Title: Valor on Washington

Re: Urban Design Commission Application - Final  
Valor on Washington: 1322 East Washington Avenue

Enclosed are updated plans for the project known as Valor on Washington. In response to feedback at the June 12, 2019 UDC meeting, we have made the following adjustments:

Sheet No.  
A203

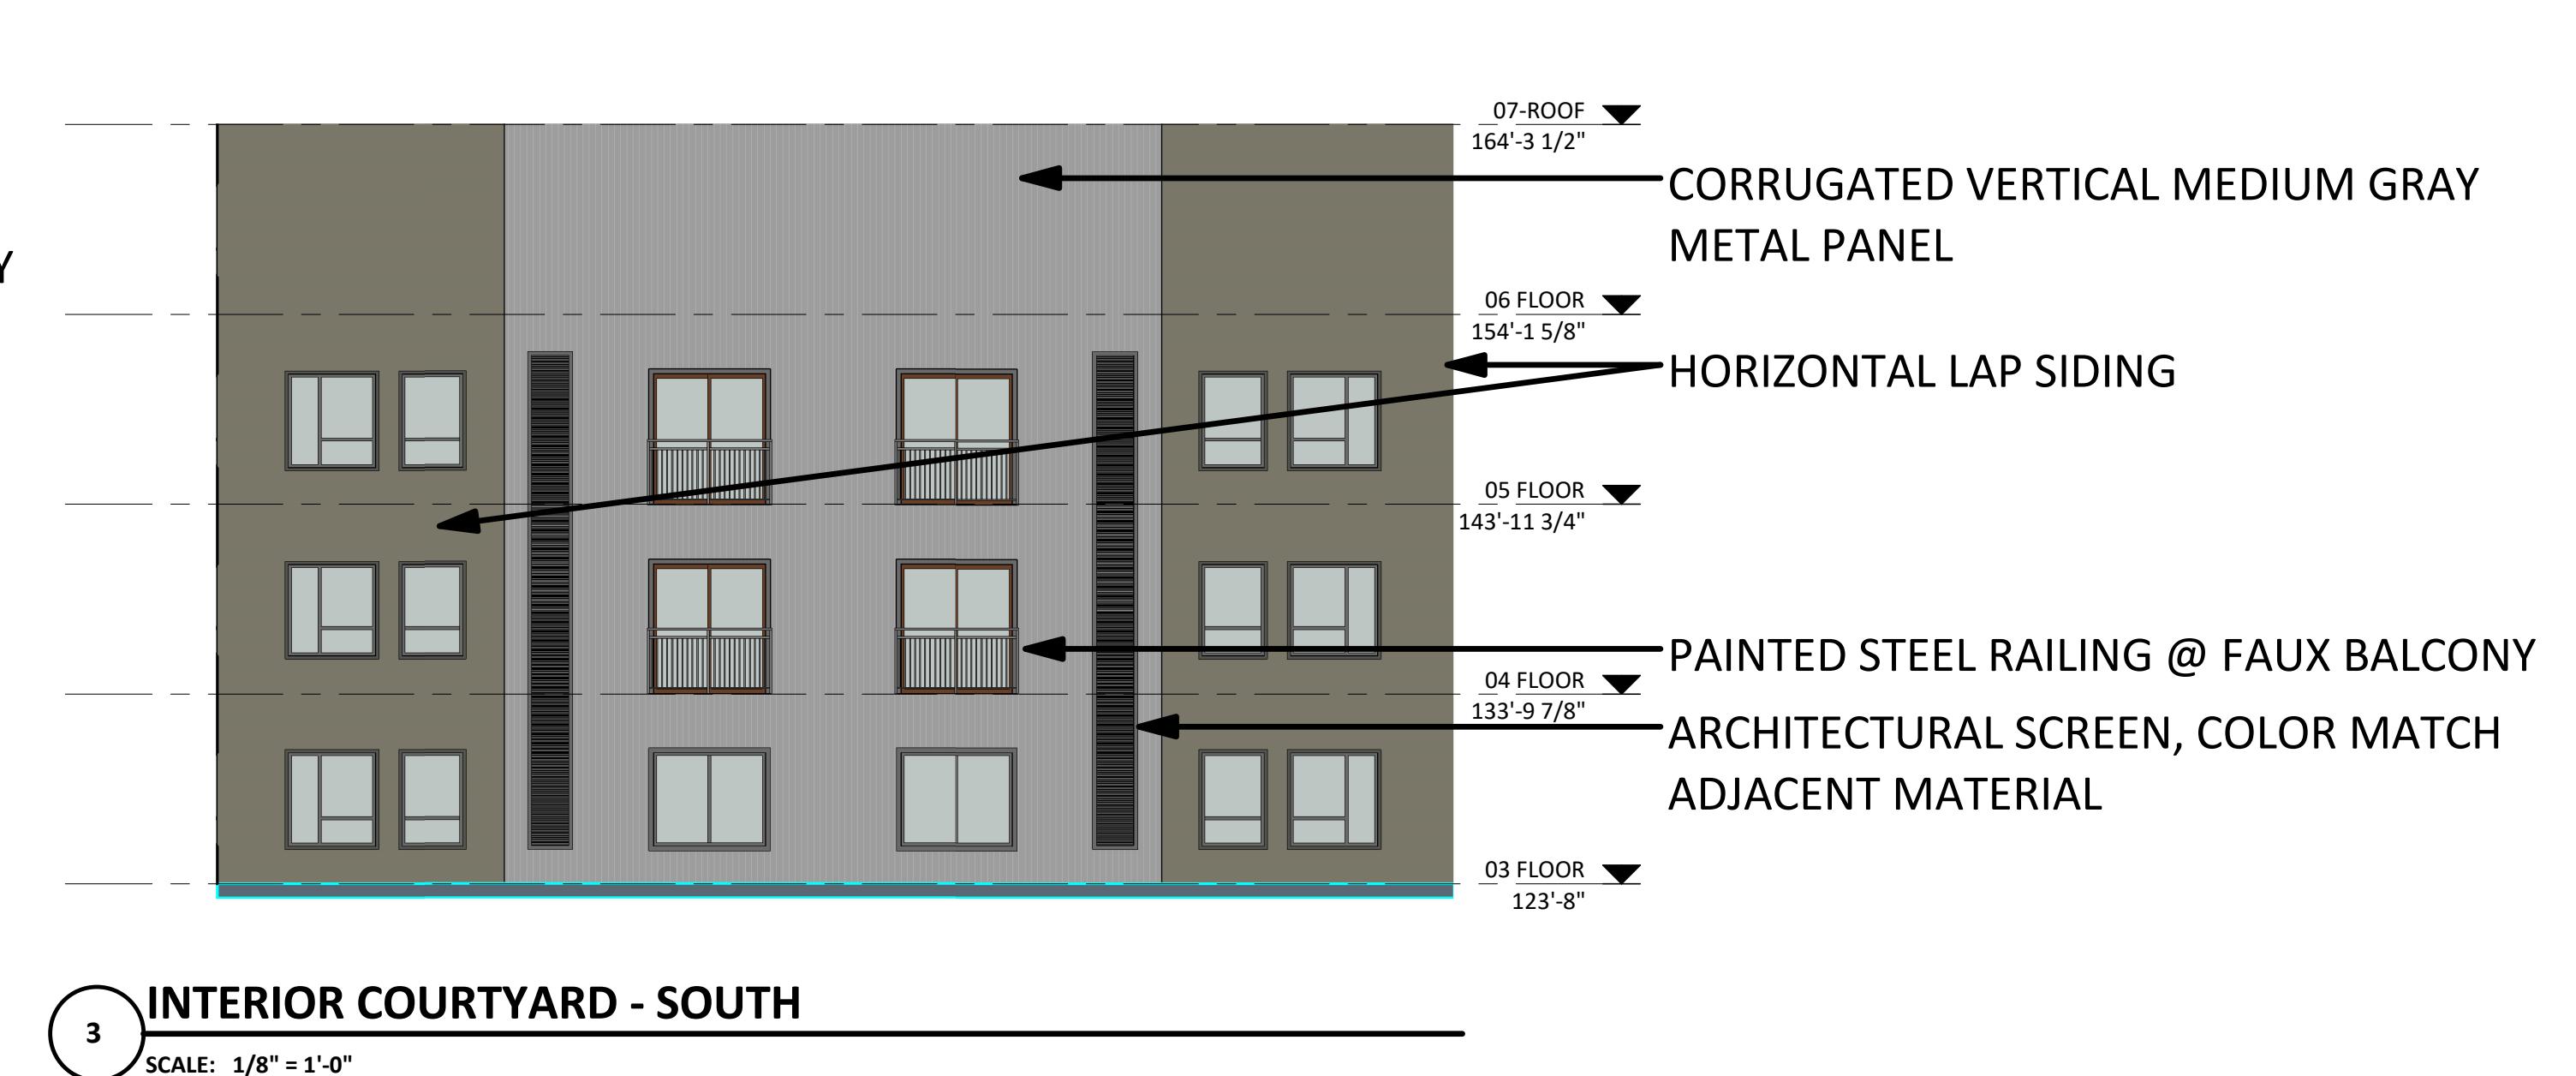
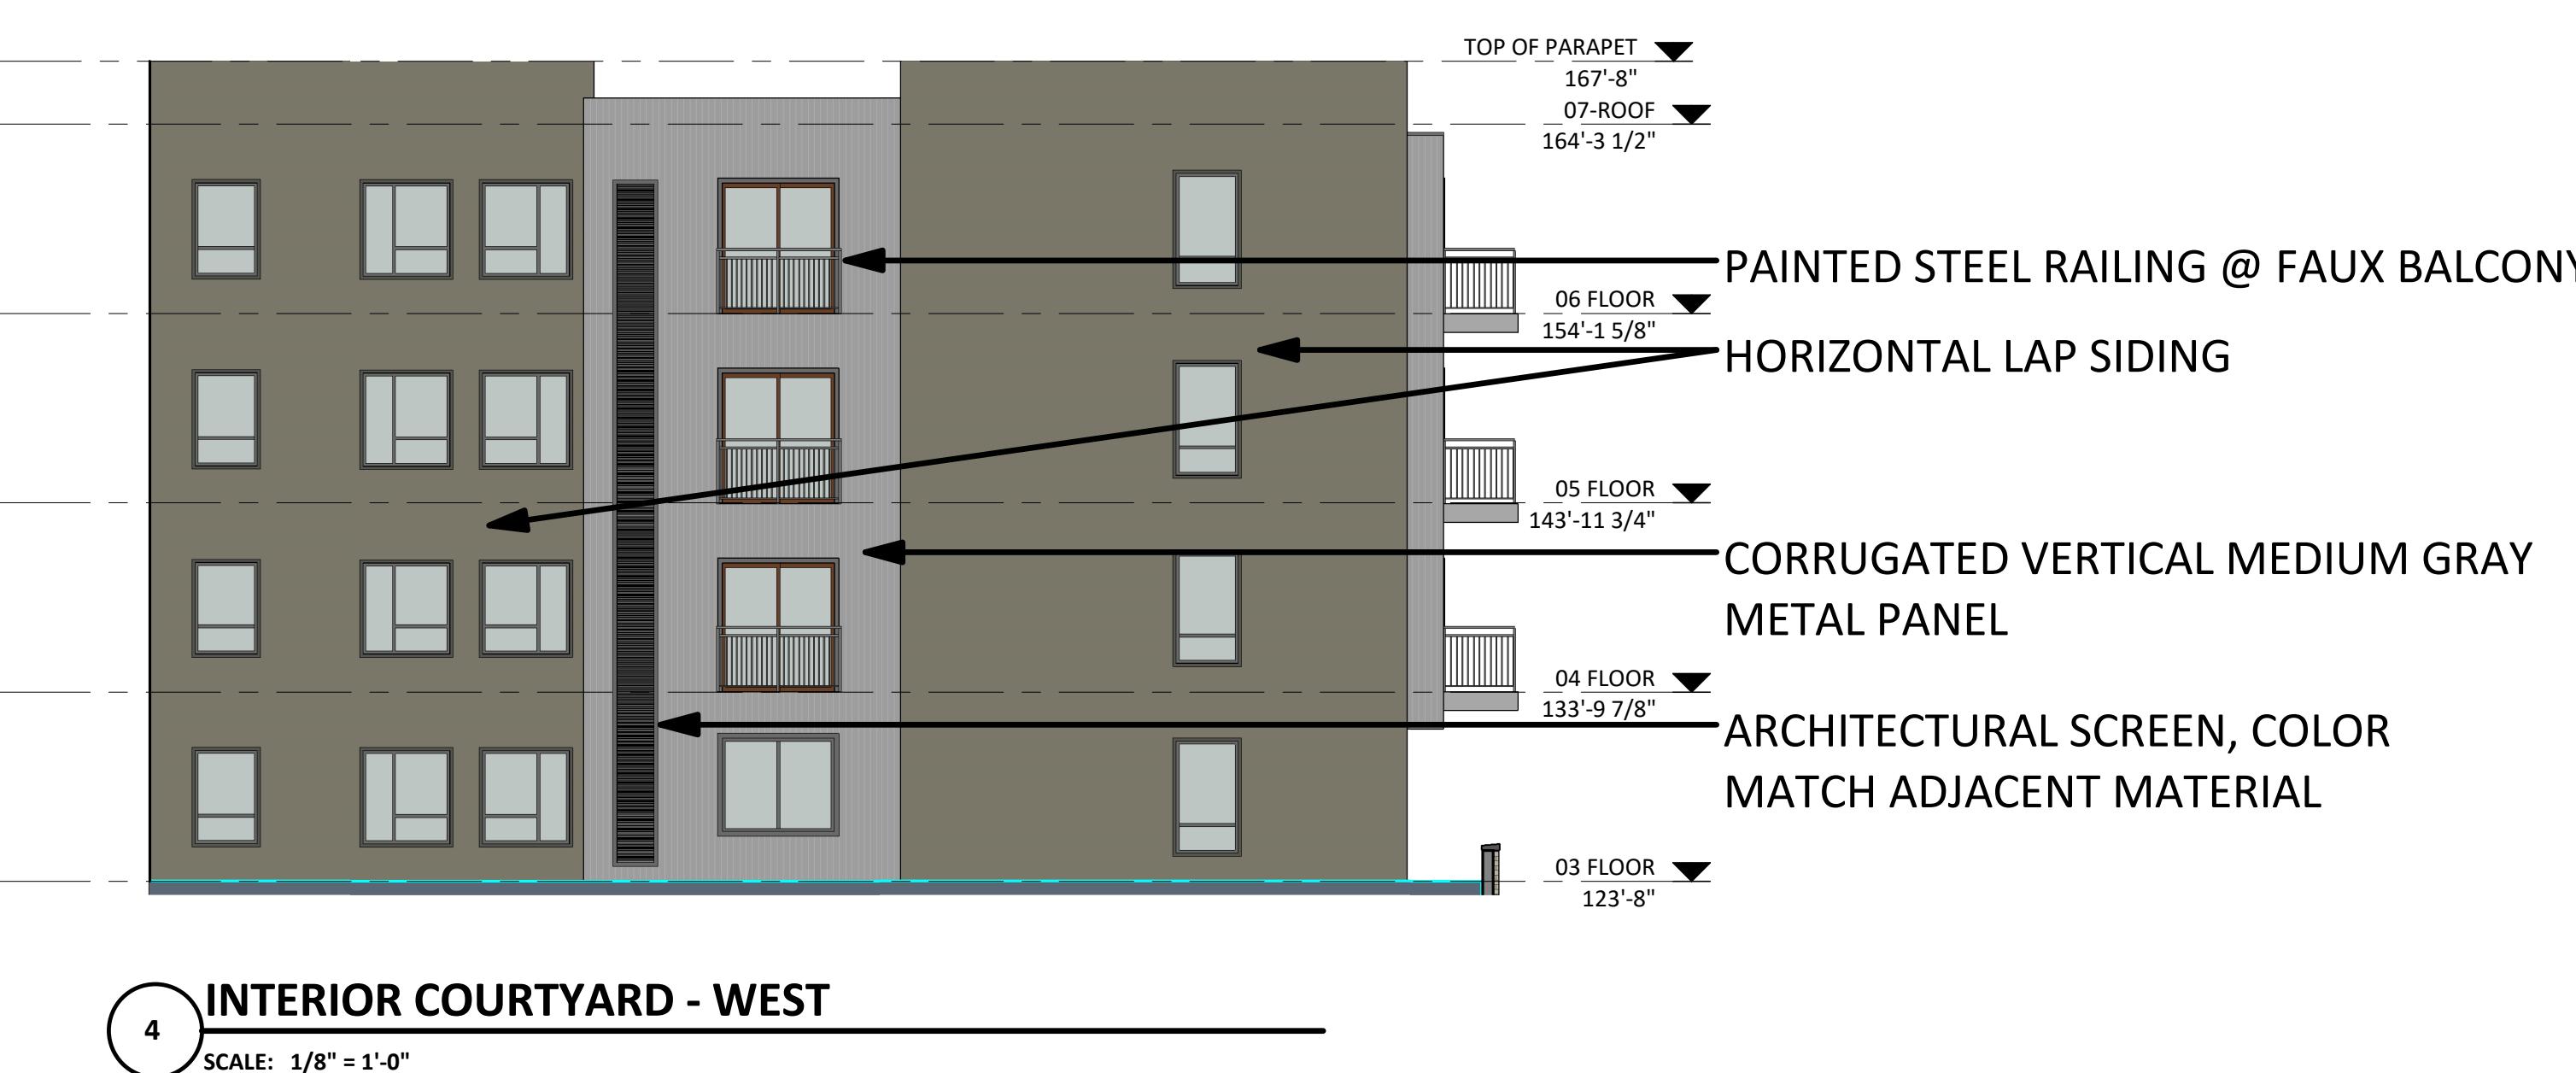
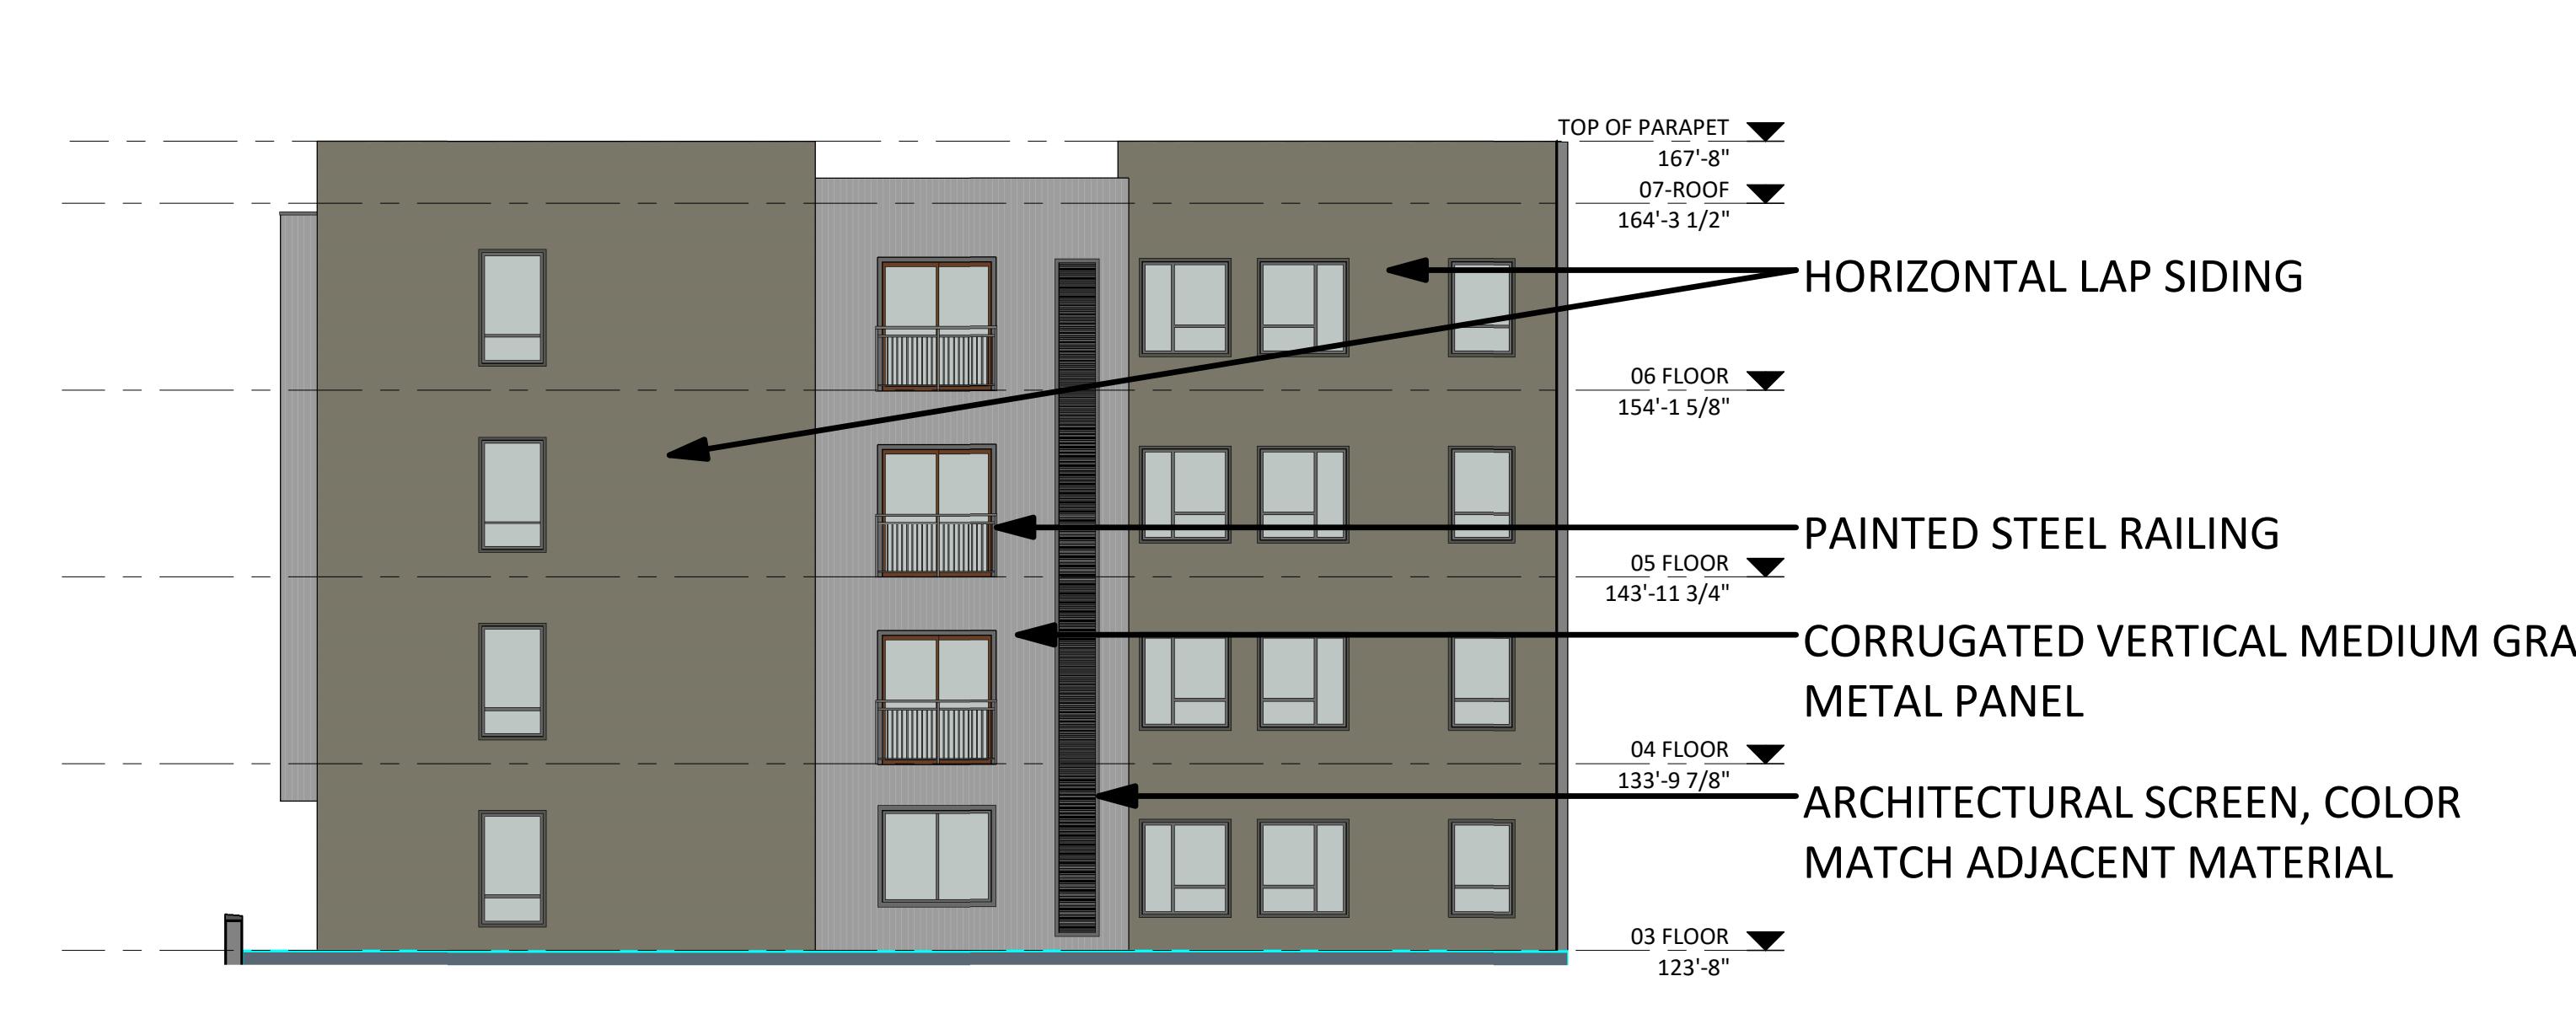
- *Metal panel gauge and installation method:* This detail shall be provided at June 26<sup>th</sup> meeting.
- *Elevation drawing views of all interior facades:* Elevation views for the north-facing lower roof building elevations are enclosed. Please refer to sheet A203.

- *Consider simplifying the material palette:* The elevations enclosed represent the following simplifications to the building elevations and materials. 1) At the request of the commission, brick has been removed from the north-facing lower roof building elevations. 2) The townhome facades material configurations have been modified/simplified. 3) the north-west building corner has been modified/simplified. Specifically, the lap siding inset has been changed to metal panel.
